DOCUMENT - 2024-346P

**Construction of the Dockstader Peel Region Paramedic Services
Reporting Station**

ADDENDUM 3

South Partial Elevation - West 1:100 A303

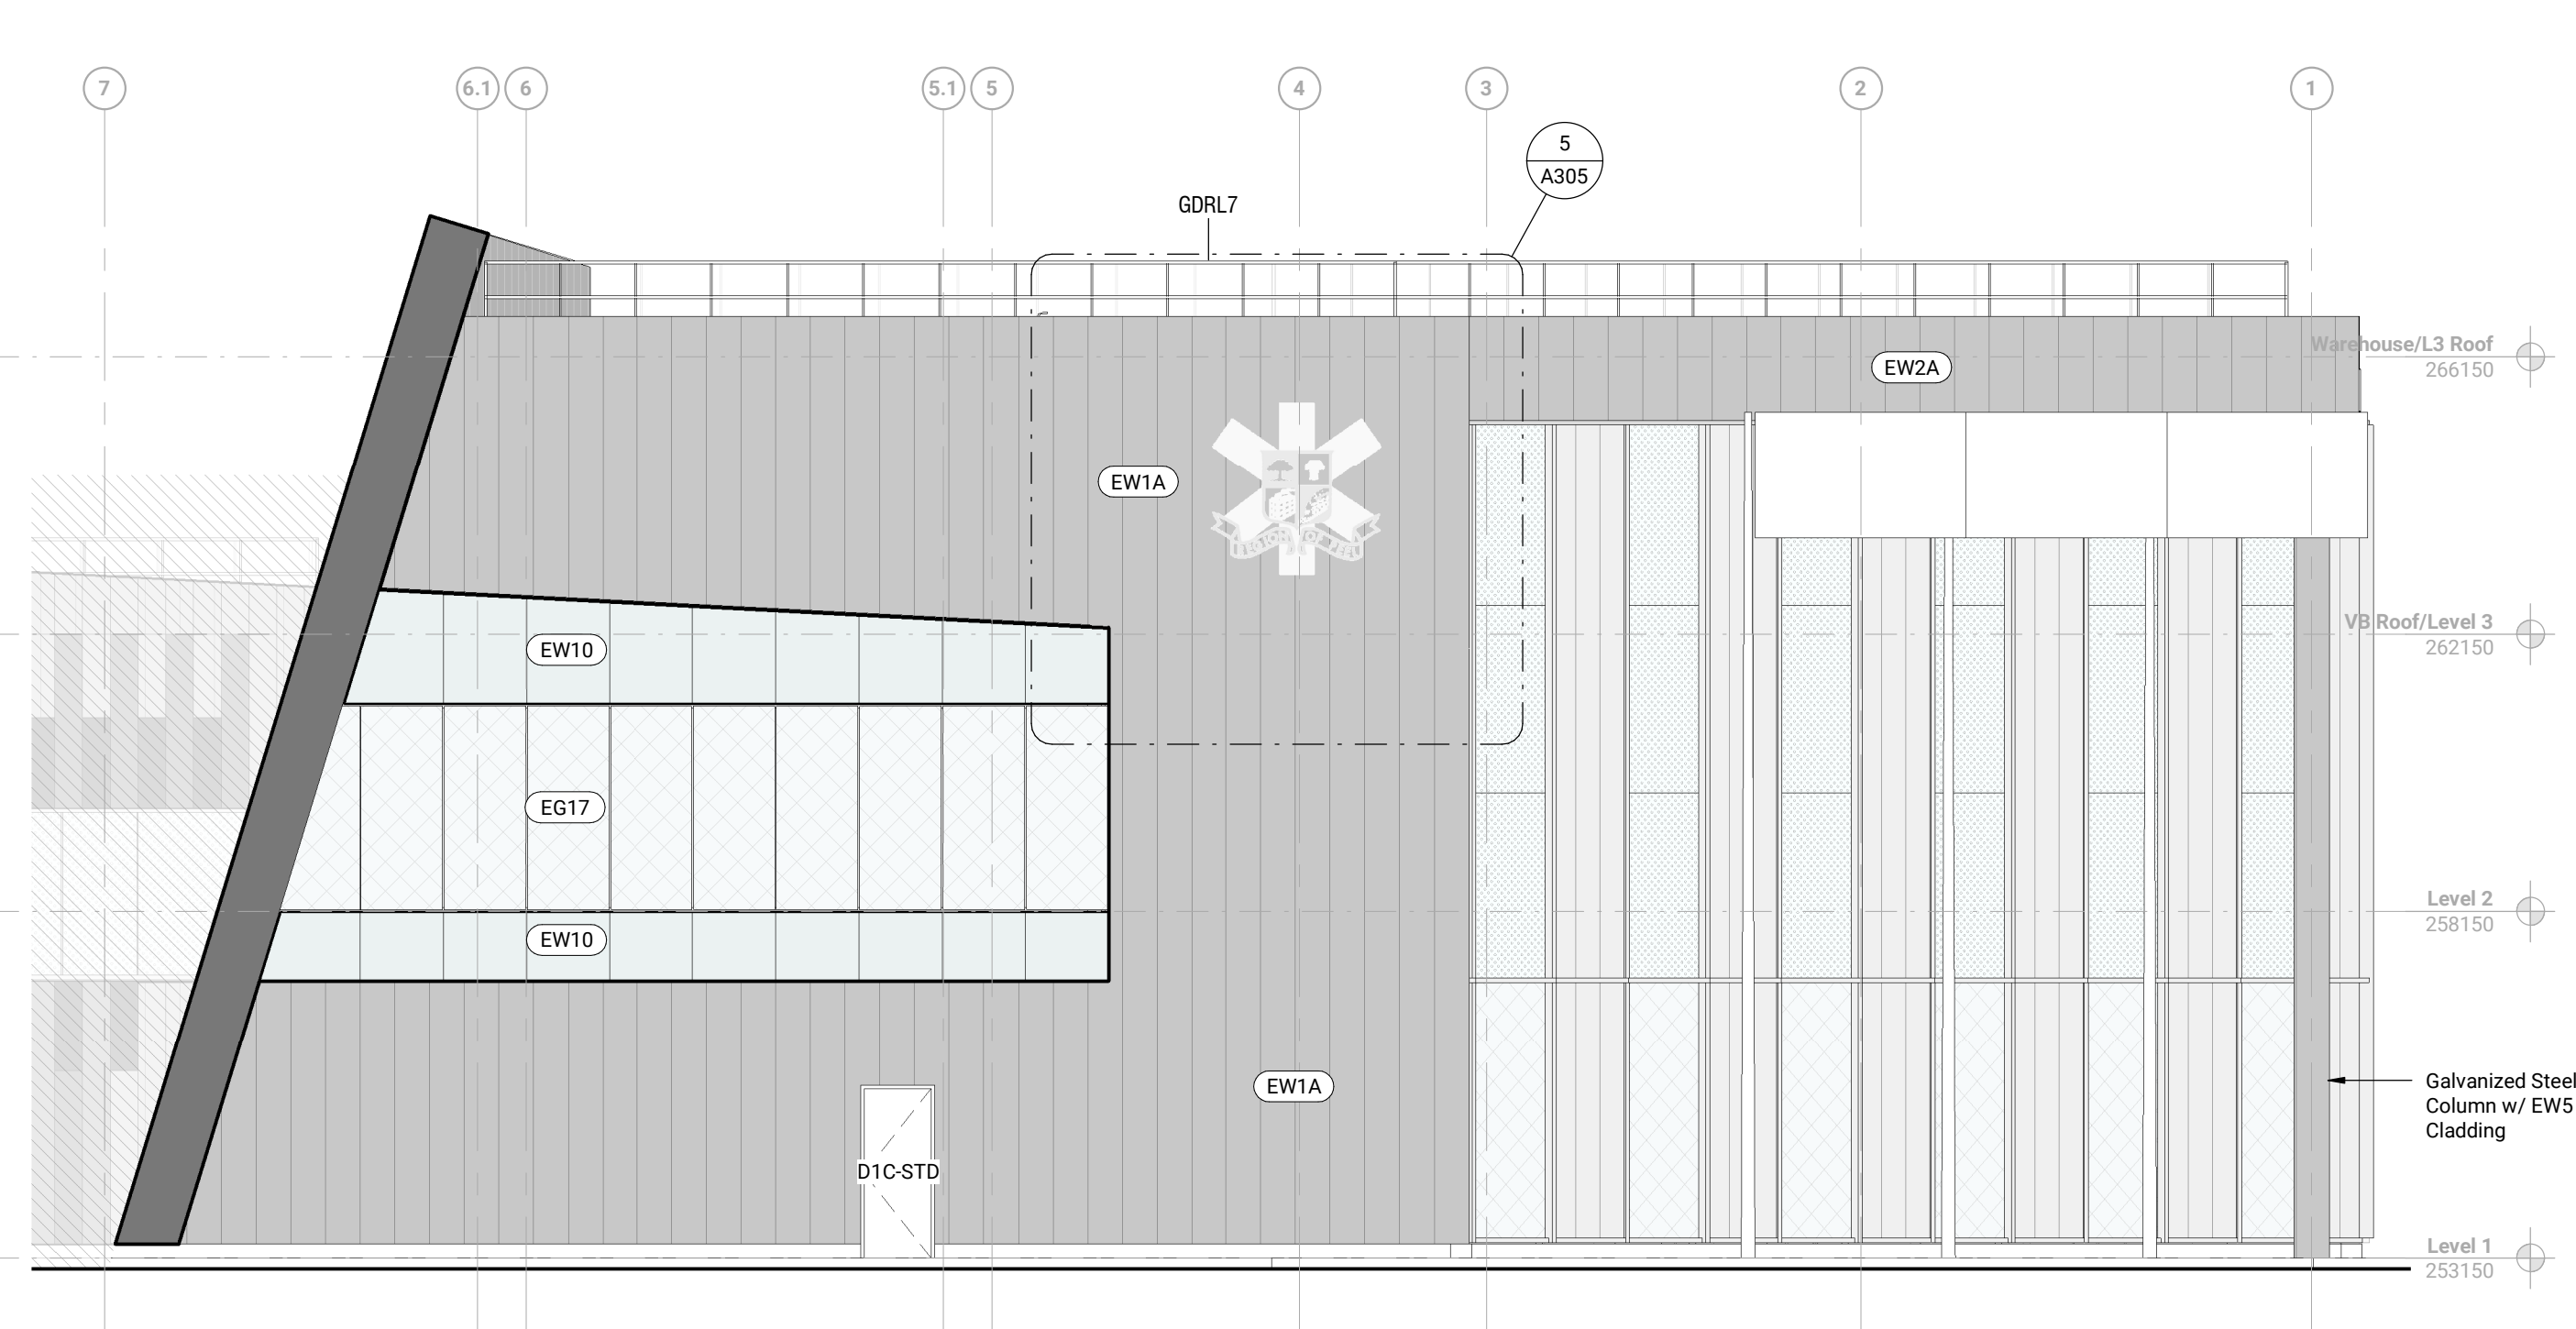
Drawing 3/A303 mentions 6mm galvanized steel plate solar wall trim, but the drawing A054 shade screen schedule not shown this 6mm plate anywhere. Please clarify.

Please refer to revised detail 3 on drawing A303 issued as part of Tender Addendum No.3. Reference to 6mm galvanized steel plate on 3/A303 has been revised to 8mm galvanized steel, as appears in A054.

Staff Entrance Canopy Section Detail 1:20 A304

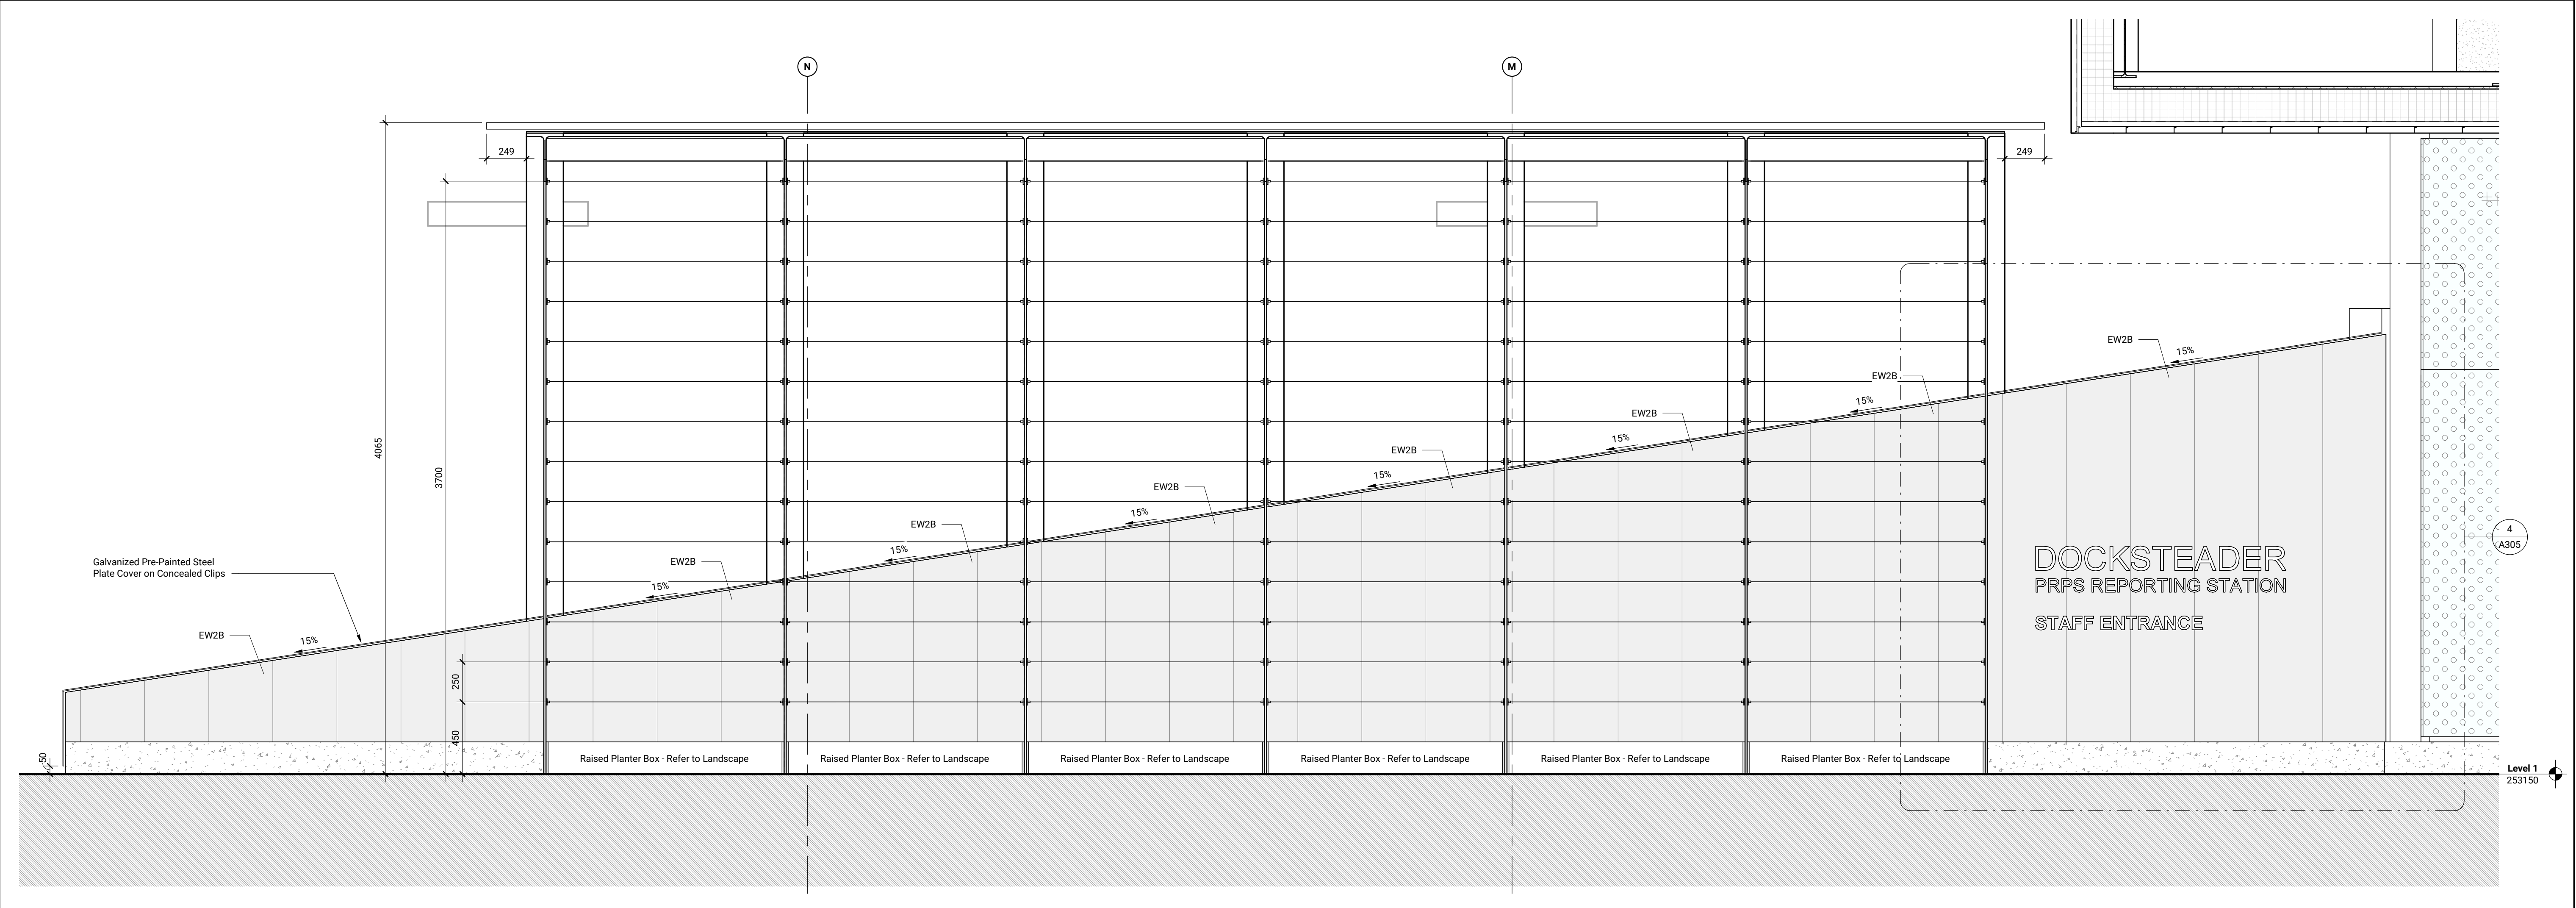
Refer to drawing 3/A304, please provide specifications and details for aircraft cable climbing plant trellis and 40x100mm pre-painted aluminum extrusion above staff entrance canopy.

Please refer to revised detail 9 on drawing A304 issued as part of Tender Addendum No.3 for aluminum extrusion sizing and mounting. Specification for cable trellis to follow as part of Tender Addendum No. 4.

Corridor North Partition Section Detail 1:10 A650 1

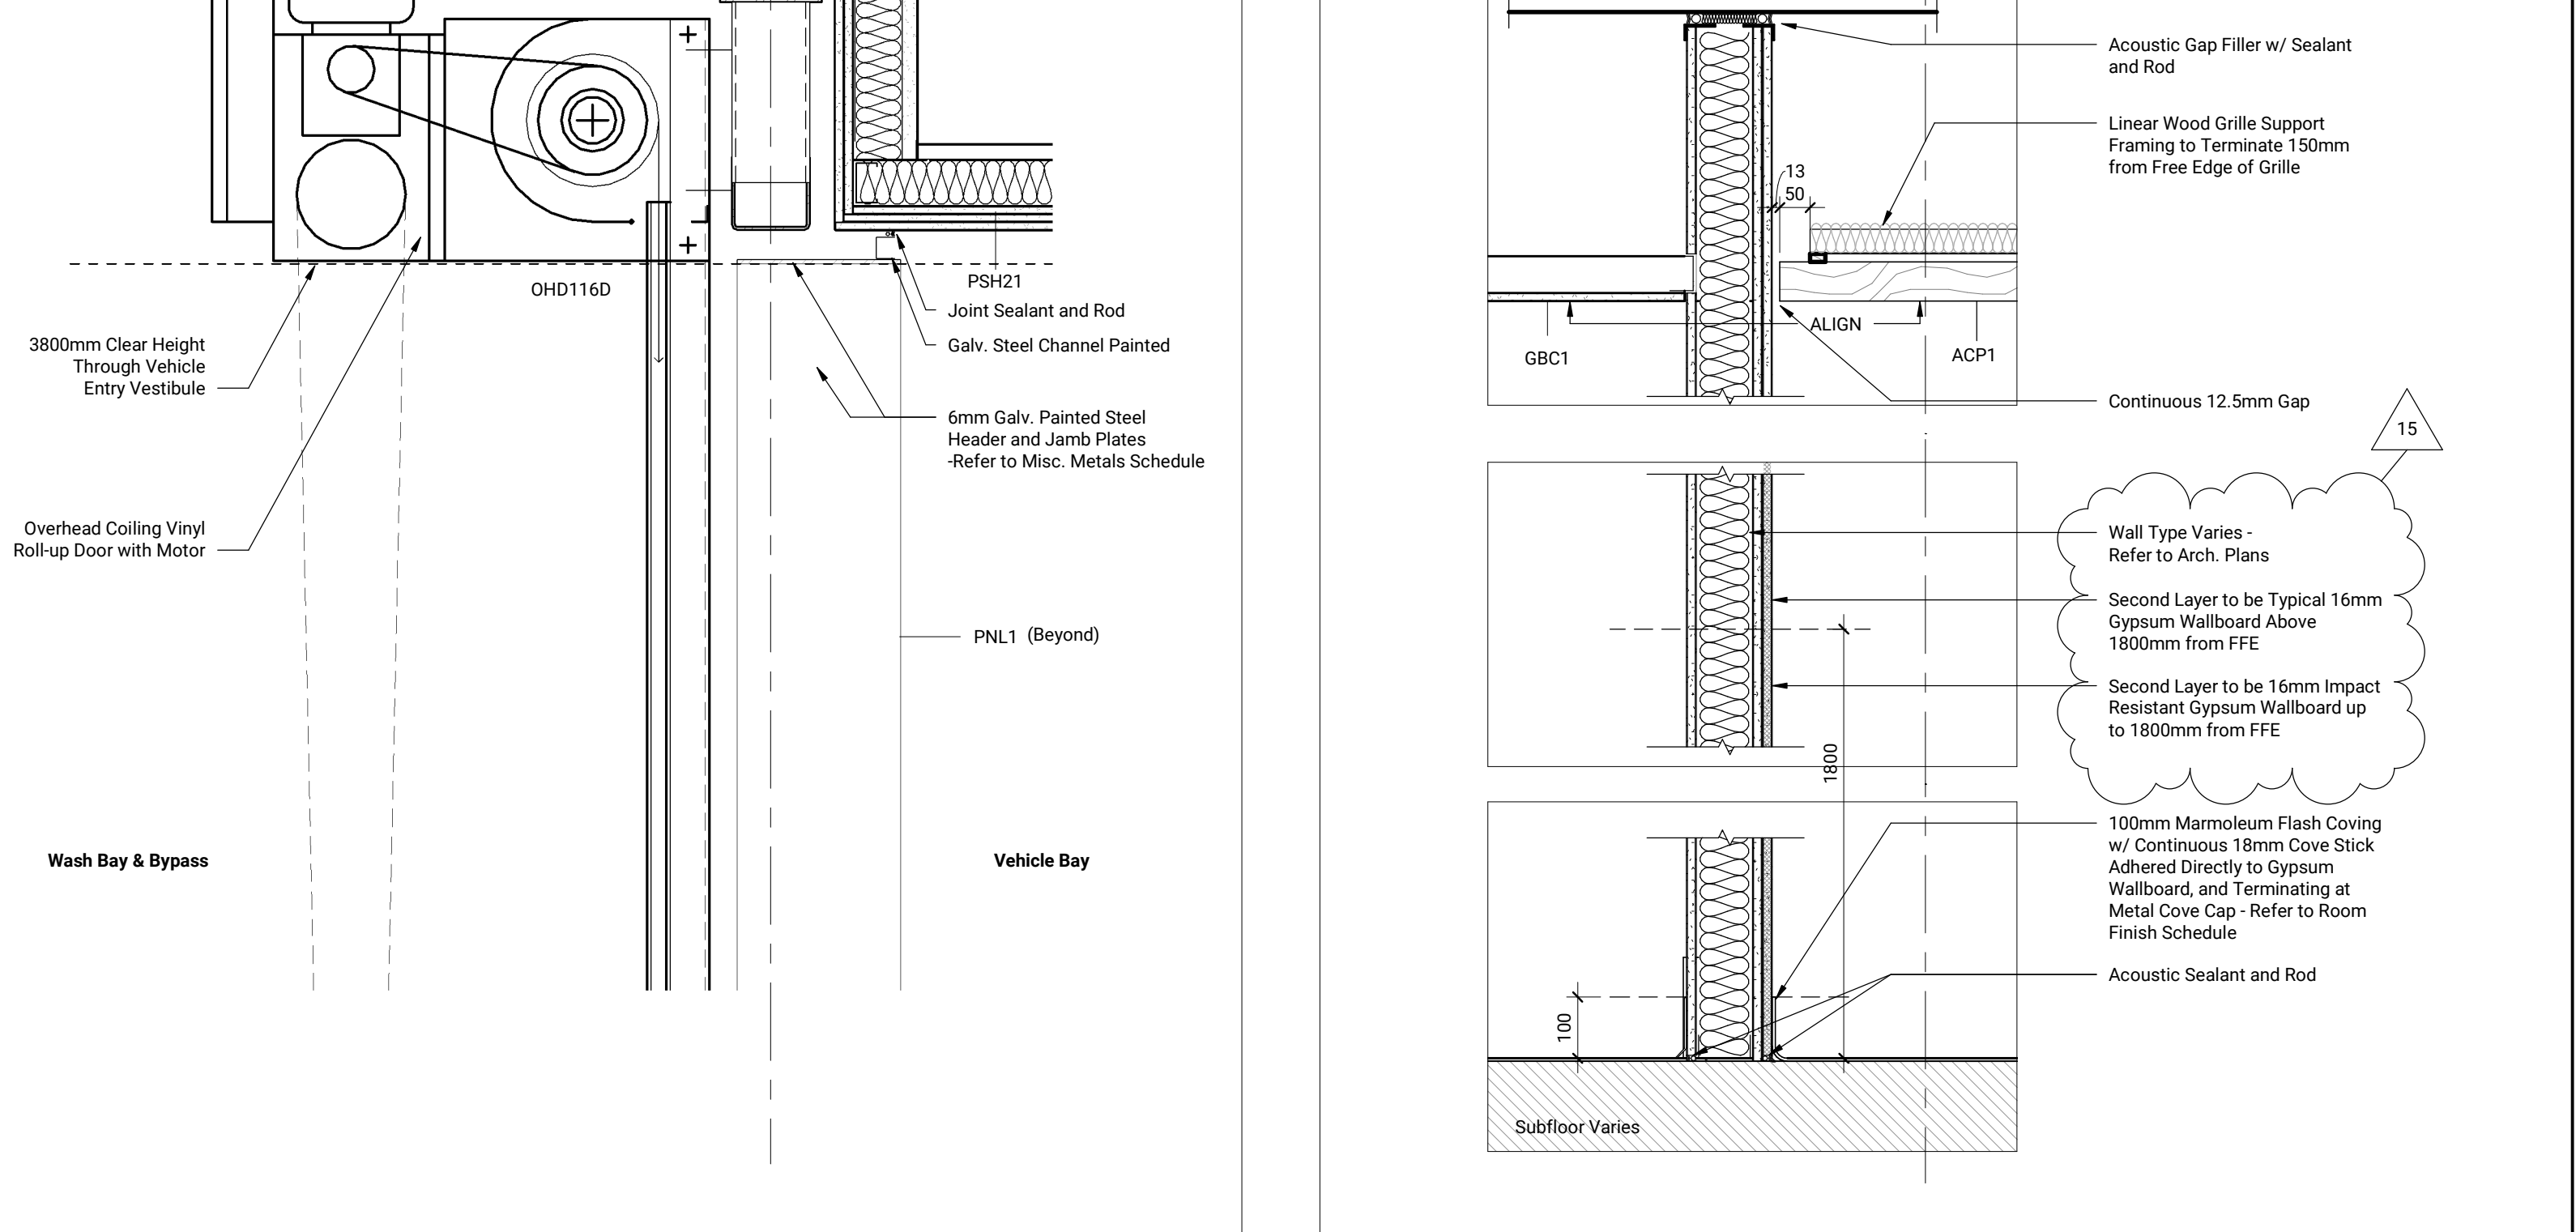
The specification in Section 10 26 23 refers to protective wall covering; however, we couldn't locate any corresponding details in the drawings. Could you please clarify the location(s) and type of protective wall coverings required?

This product is no longer being used and abuse / impact resistant gypsum board used in its place. Specification Section 10 26 23 is being deleted as part of Tender Addendum No. 3, and please refer to revised Specification Section 09 21 16 and revised detail 1 on drawing A650 issued as part of Tender Addendum No. 3.
